Service-Information Motorcycle

**Rear Wheel
Drive**

**33 017 92
(2506)**

Rear Shock Adjustment Knob Numbering - R100GS 1991 Models

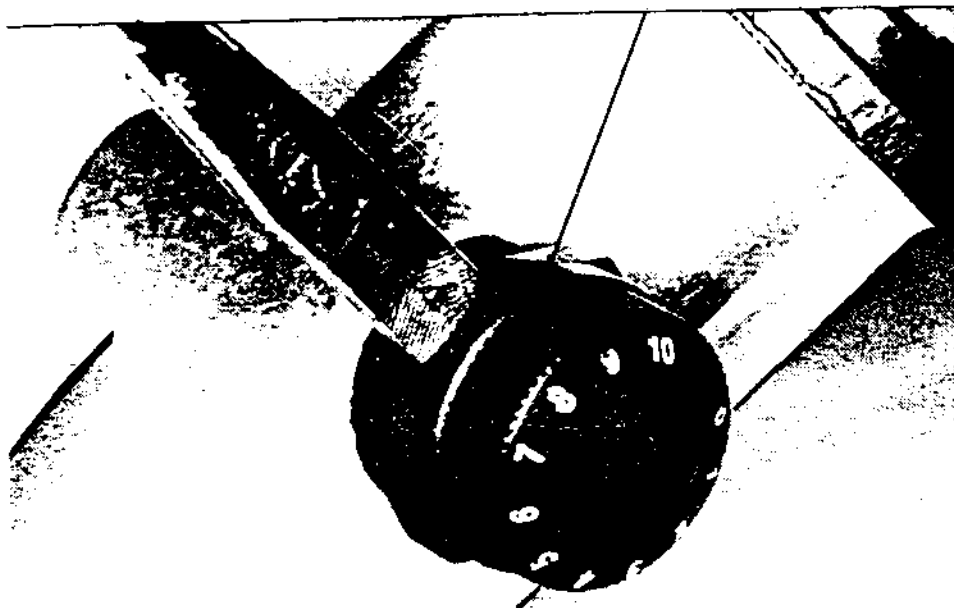
Complaint: The white numbers on the rear shock adjusting knob have a tendency to come off.

Remedy: Future adjusting knobs will have raised numbers. Replace the adjusting knob with:

Part No. 33 53 2 314 139

- Instructions:**
- Turn the knob to the maximum (position 10)
 - Using a center punch, put a mark on the plastic nut which is below the knob
 - Pry the knob off gently, using a screwdriver
 - Using a plastic hammer, drive the new adjusting knob on with the Figure 10 aligned with your center punch mark:
